## **Burlington Design Advisory Board**

### **DESIGN ADVISORY BOARD Tuesday October 27, 2020 3:00 PM REMOTE MEETING**

**To:** The Design Advisory Board  
**From:** Mary O'Neil, AICP, Principal Planner  
**RE:** ZP21-0358CA/CU; 40 Kingsland Terrace  
**Date:** October 27, 2020

**To:** The Design Advisory Board  
**From:** Mary O'Neil, AICP, Principal Planner  
**RE:** 323-325 College Street  
**Date:** October 13, 2020

SITE PLAN -  
PROPOSED  
A.02

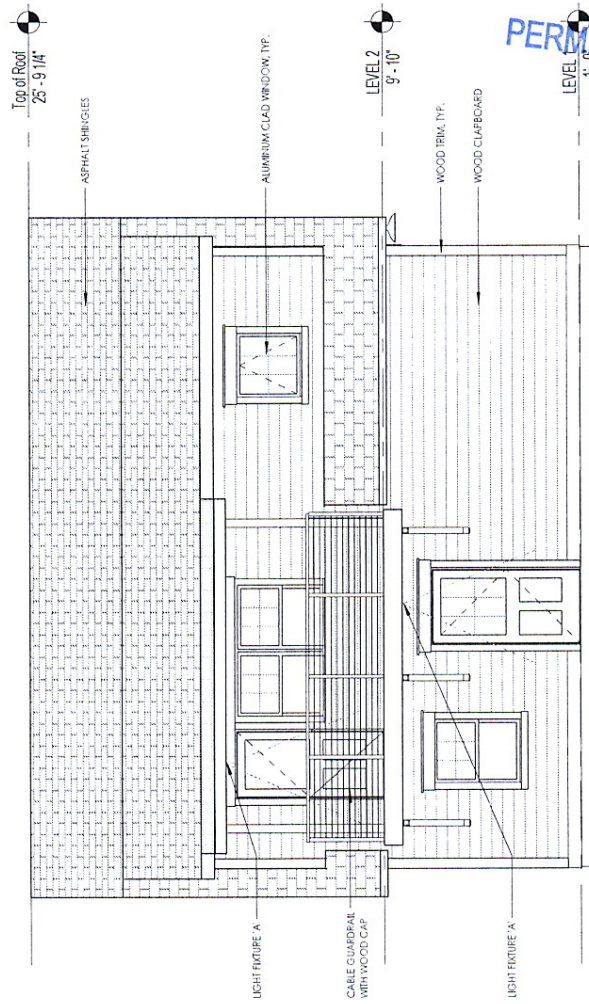
Vehicular access is proposed to continue as existing; from Kingsland Terrace. The driveway is proposed to be widened (although the plan does not provide that dimension.) Driveways are limited to 18' in width.

The plan assumes pedestrian access from the driveway. The driveway should physically isolate a pedestrian path to separate vehicular circulation from pedestrian.

1. The plan does not meet required dimensional standards regarding rear yard setback. As proposed, the project cannot be approved.
2. A segregated pedestrian path shall be introduced to the new structure to separate vehicular and pedestrian traffic.

3. Driveways are limited to 18' in width.
4. No landscaping plan has been submitted with the application. The applicant shall provide an intended planting schedule and/or fencing changes prior to review by the Development Review Board.

1 North Elevation  
1/8" = 1'-0"

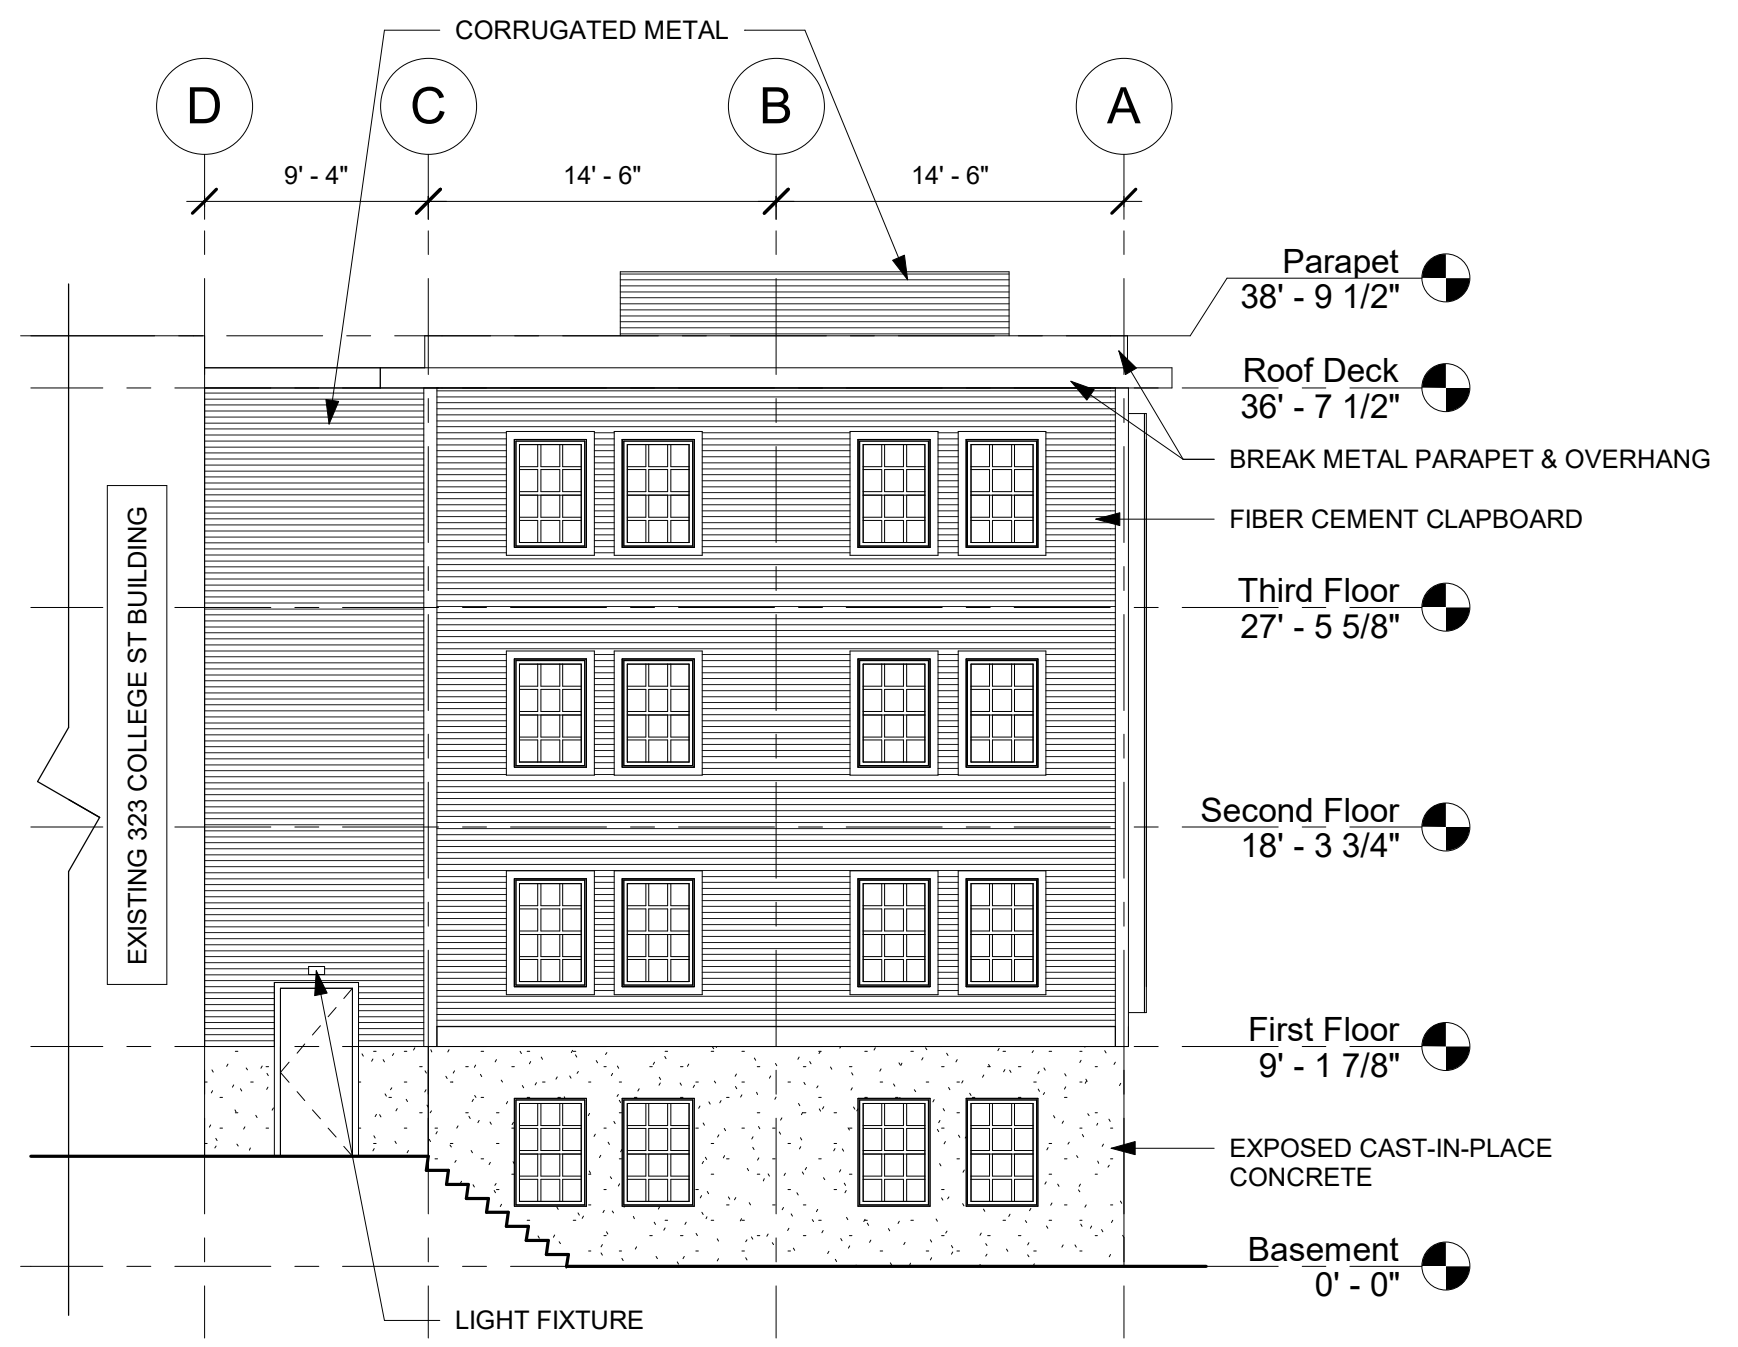
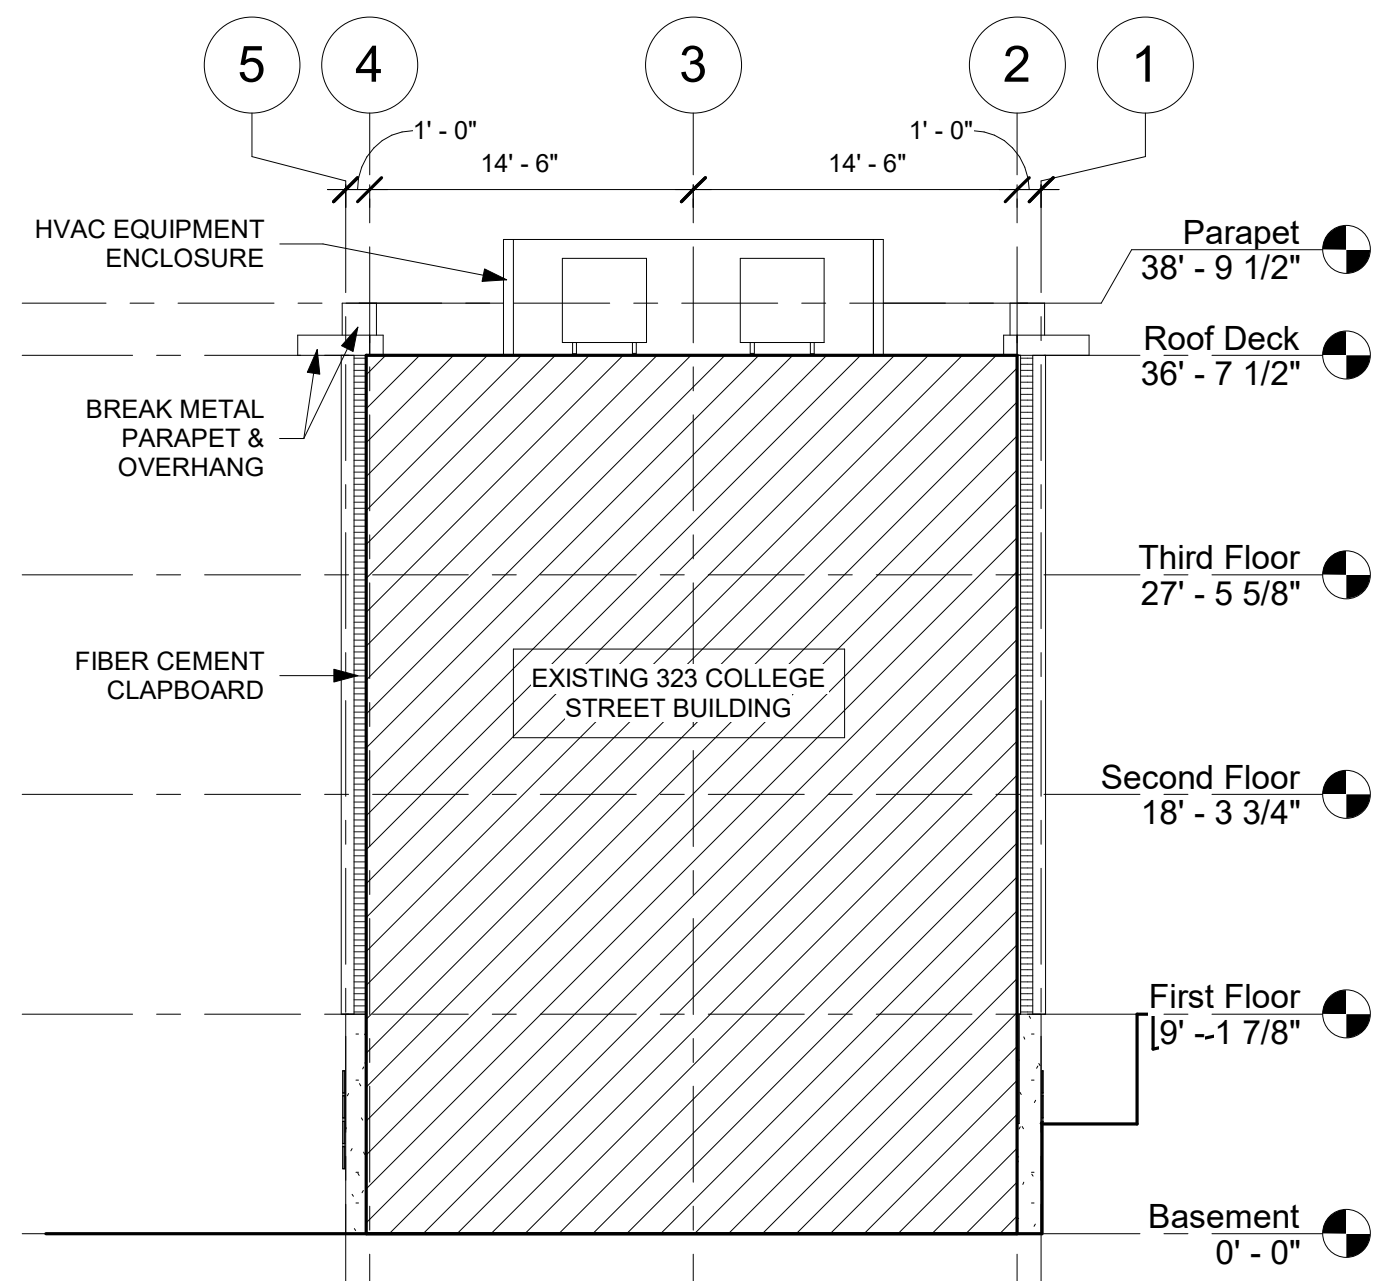
Doors are illustrated on both the east and west elevations (Plan A200), neither of which appears to afford any canopy. Some method of roof cover should be provided to allow residents sheltered transition upon entry.

Exterior downlights are proposed over both new entries. See elevations on plan A200.

3. Some form of roof canopy shall be provided for both building entrances to ensure shelter from inclement weather.
4. Floor and roof plans shall be submitted.

**Existing Conditions  
Plan of Land**

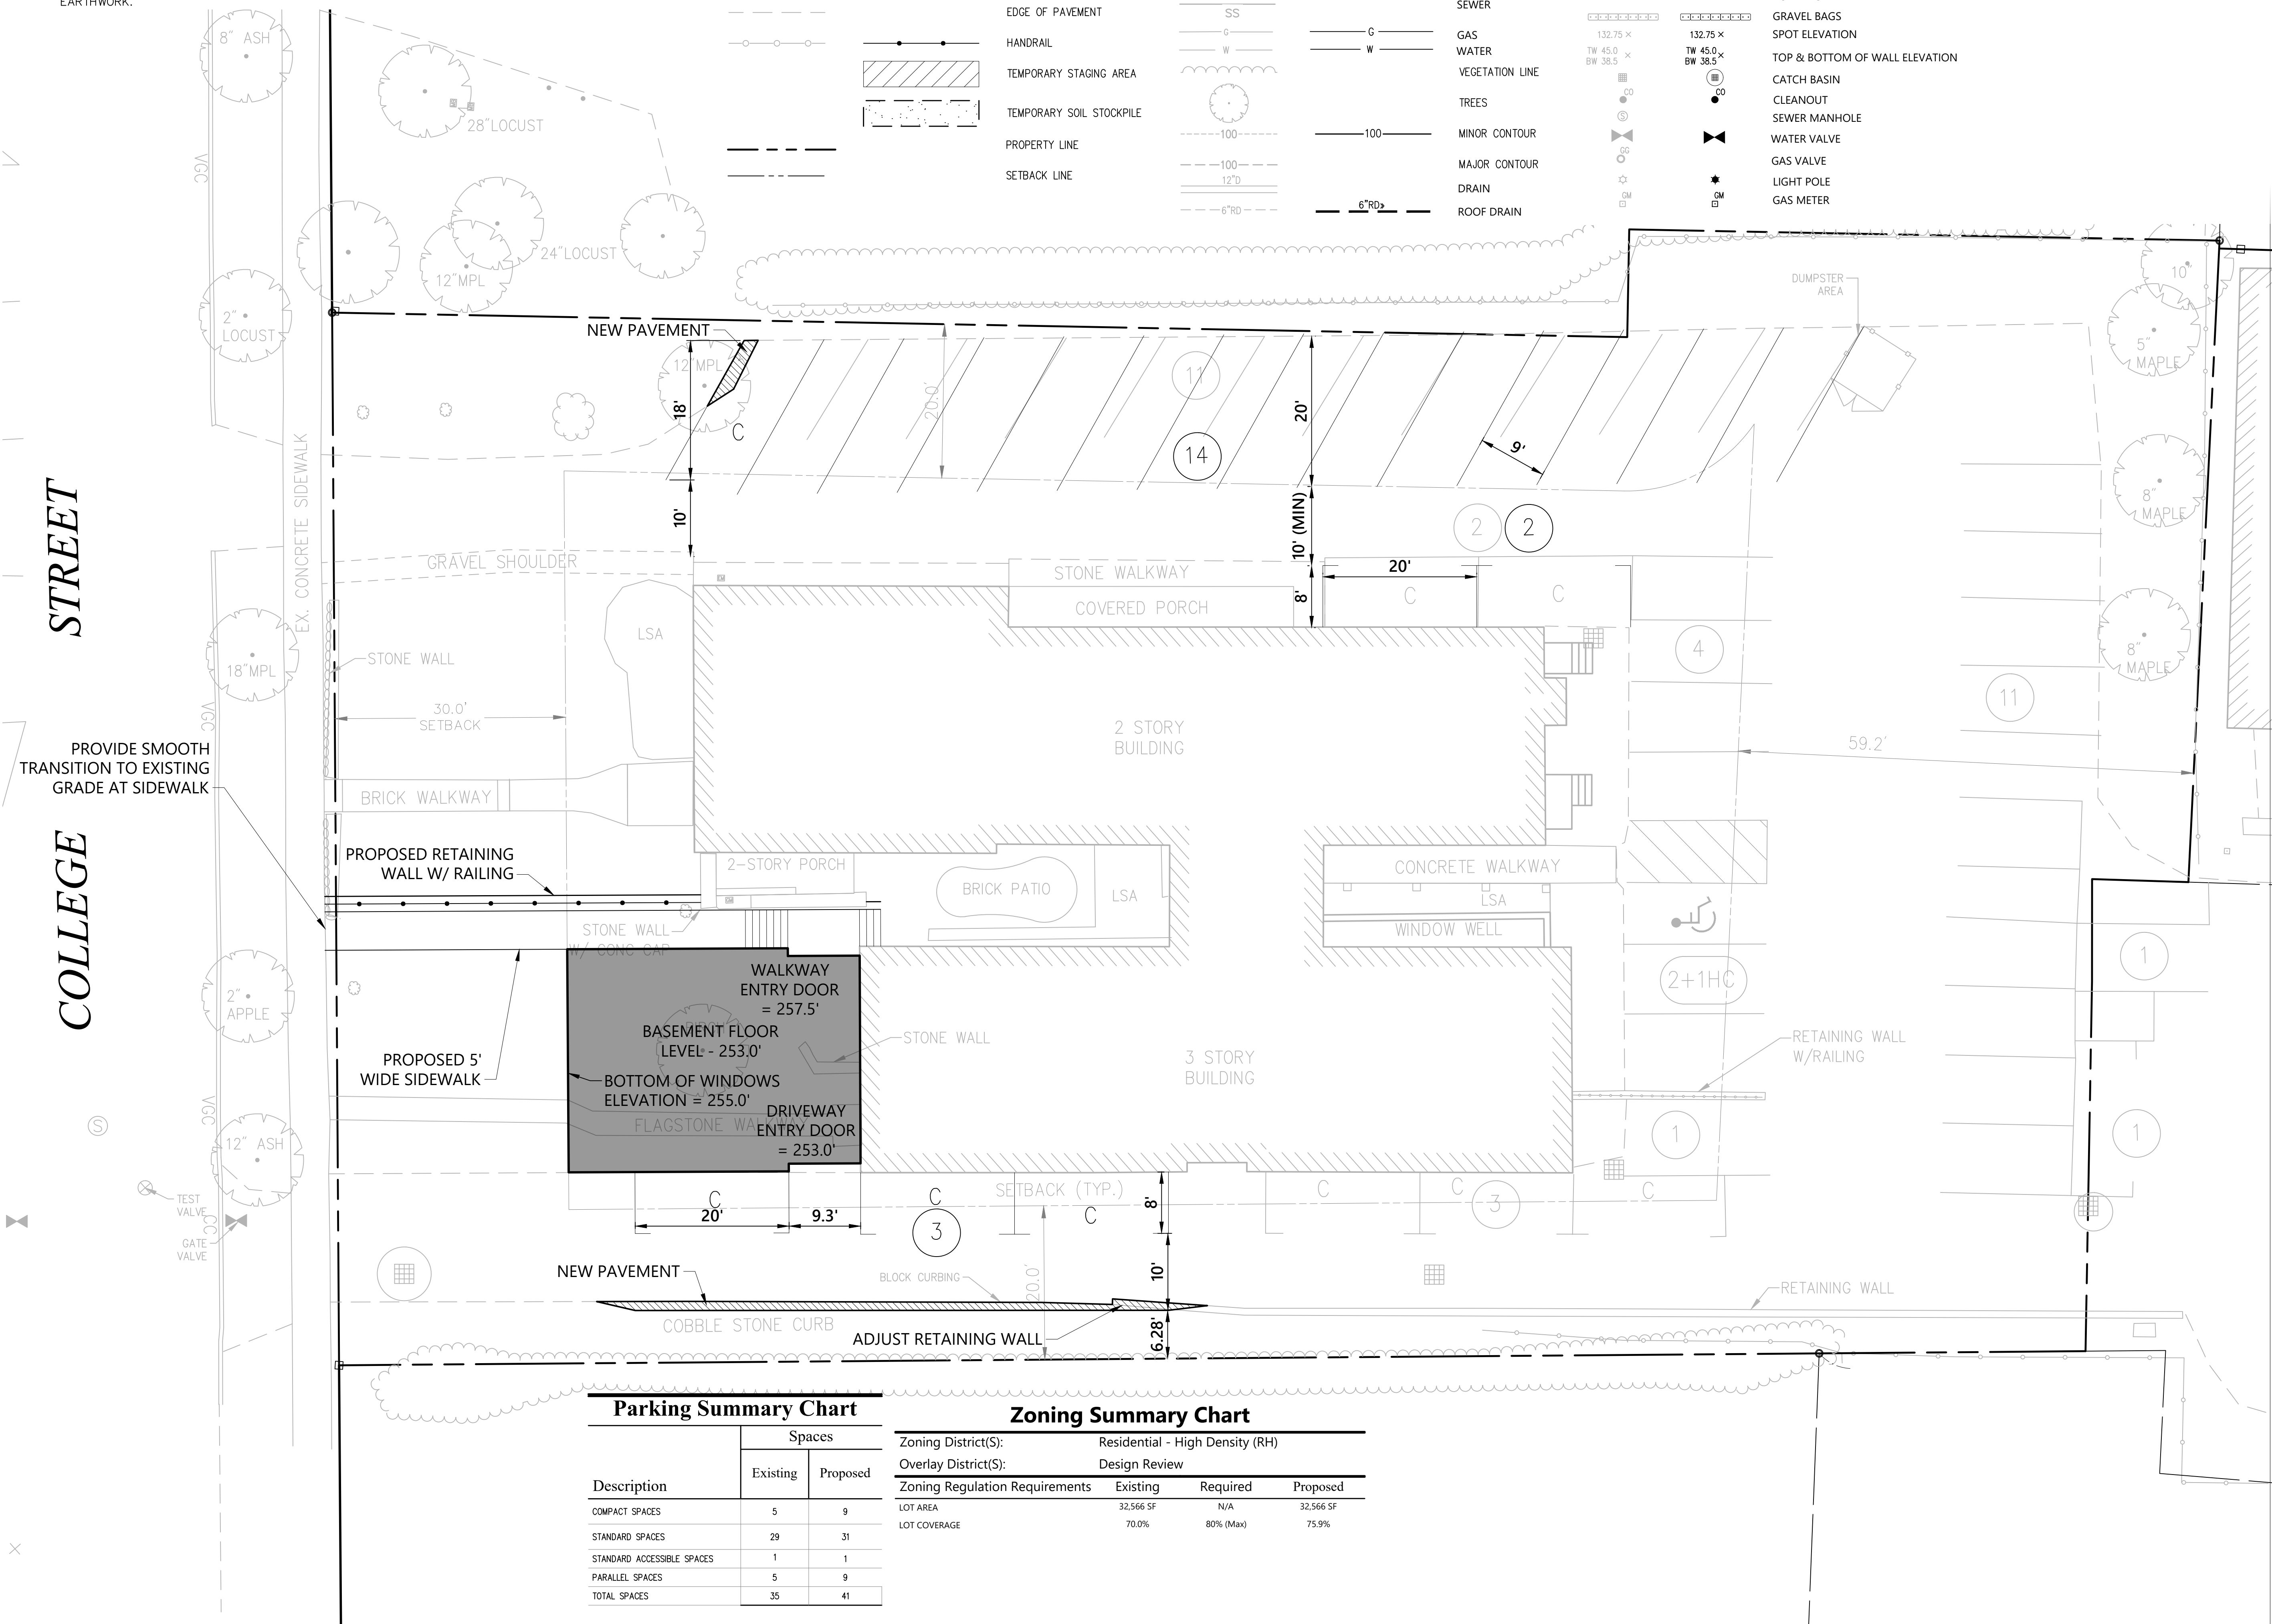
Plan Sv-1 shows a birch tree in the location of the proposed addition. Google Earth also illustrates an unidentified tree (Pine?) in the front yard that does not appear on the existing conditions plan. The applicant shall define.

1. A landscaping plan, included proposed tree removal shall be provided.
2. Written approval of the Erosion Prevention and Sediment Control Plan, as well as the Stormwater plan will be a condition of any approval.
